SUBJECT: ISSUANCE OF AMENDMENT NO. 41 TO FACILITY OPERATING LICENSE
NO. NPF-29 - GRAND GULF NUCLEAR STATION, UNIT 1, REGARDING
CHANGES TO TECHNICAL SPECIFICATIONS FOR ANTICIPATED TRANSIENT
WITHOUT SCRAM (ATWS) MODIFICATIONS (TAC NO. 65969)

MISSISSIPPI POWER & LIGHT COMPANY
SYSTEM ENERGY RESOURCES, INC.
SOUTH MISSISSIPPI ELECTRIC POWER ASSOCIATION
DOCKET NO. 50-416
GRAND GULF NUCLEAR STATION, UNIT 1
AMENDMENT TO FACILITY OPERATING LICENSE

Amendment No. 41
License No. NPF-29

ATTACHMENT TO LICENSE AMENDMENT NO. 41

FIGURE 3.1.5-1 SODIUM PENTABORATE SOLUTION TEMPERATURE/CONCENTRATION REQUIREMENTS

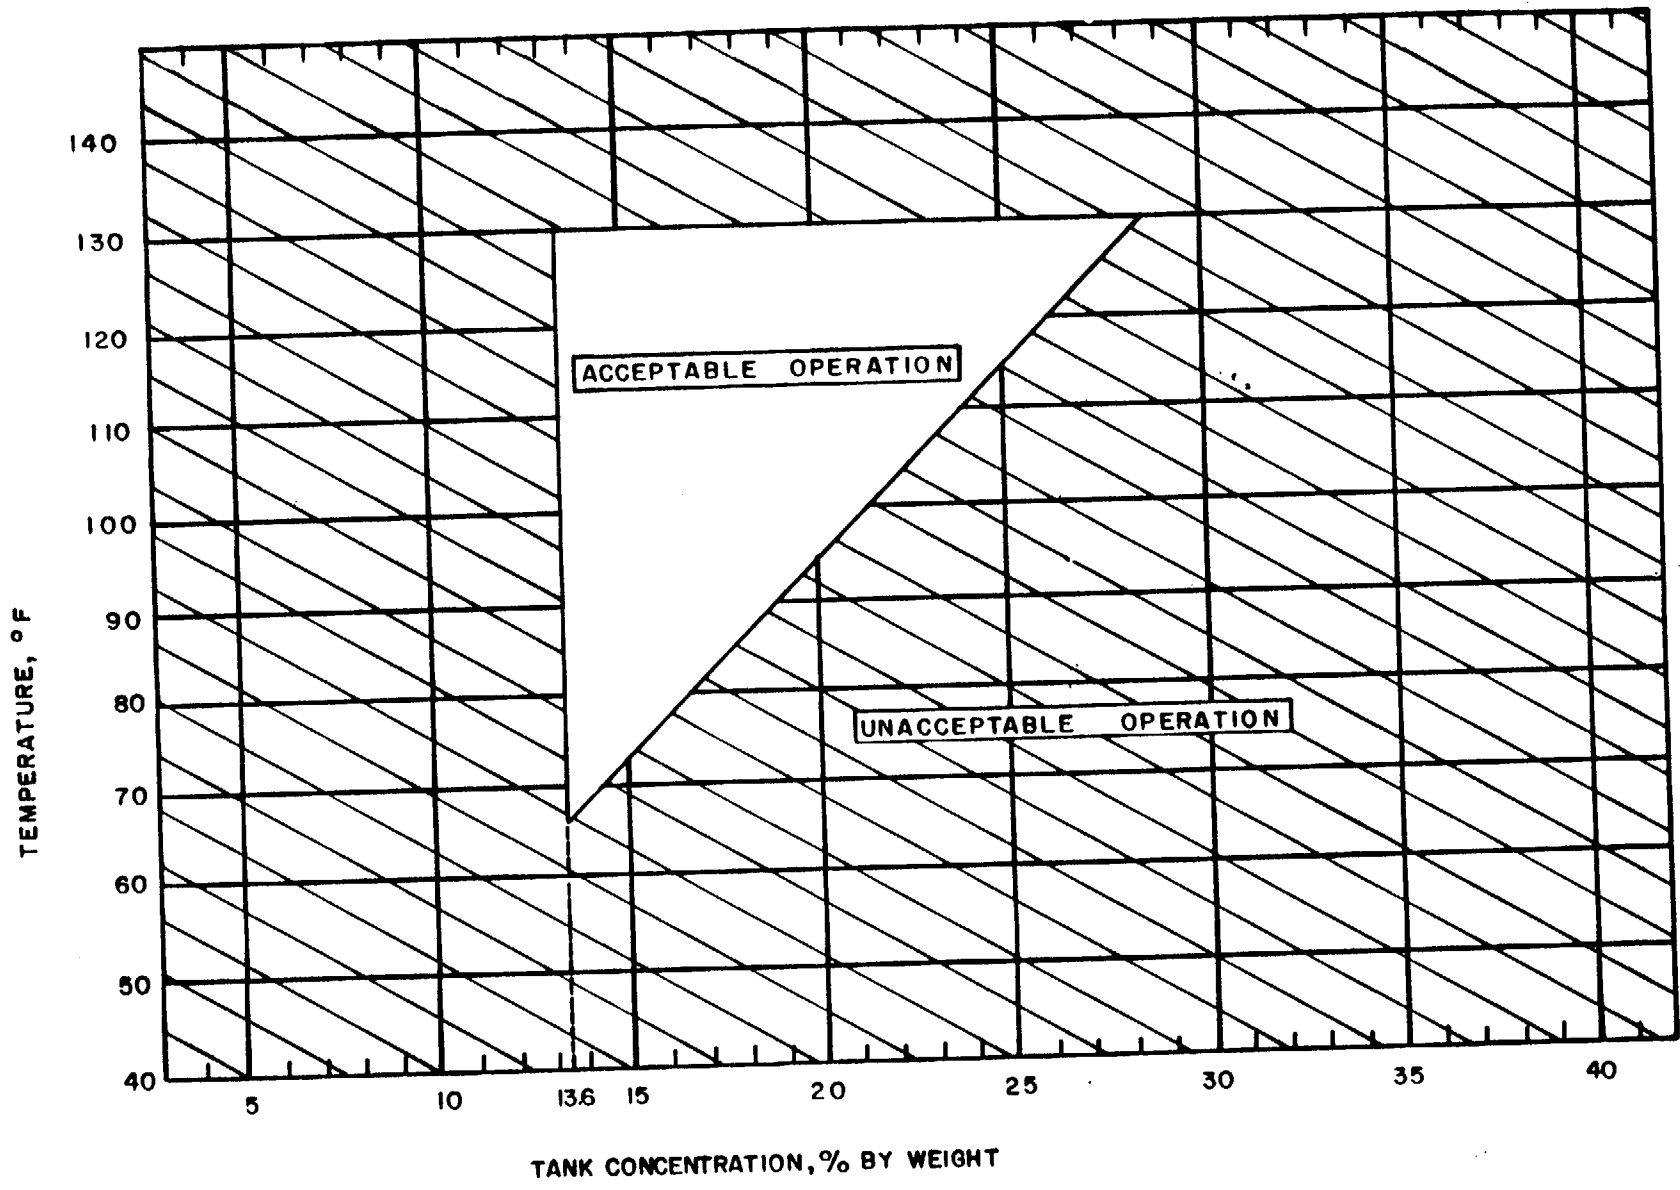
The TS for the SLCS would be changed by (1) adding maximum temperature and minimum concentration limits in TS Figure 3.1.5-1, "Sodium Pentaborate Solution Temperature/Concentration Requirements," (2) changing surveillance requirements in TS Section 4.1.5 to meet requirements for ATWS, as well as other design basis accidents, and (3) revising the TS Bases Section 3/4.1.5 to reflect system modifications for ATWS.

With respect to TS Figure 3.1.5-1, the curve of temperature versus concentration required to keep sodium pentaborate in solution remains the same, but minimum sodium pentaborate concentration is limited to that required for an ATWS (13.6% by weight) and maximum temperature is limited to that required to assure adequate suction head for the SLCS pumps (130°F). These changes are consistent with ATWS requirements and are acceptable.

1. The limiting temperature of the SLCS pump suction piping is changed from "greater than or equal to 70°F" to the requirements of the new TS Figure 3.1.5-1. This change provides consistency with the temperature limits in the new figure and is, therefore, acceptable.
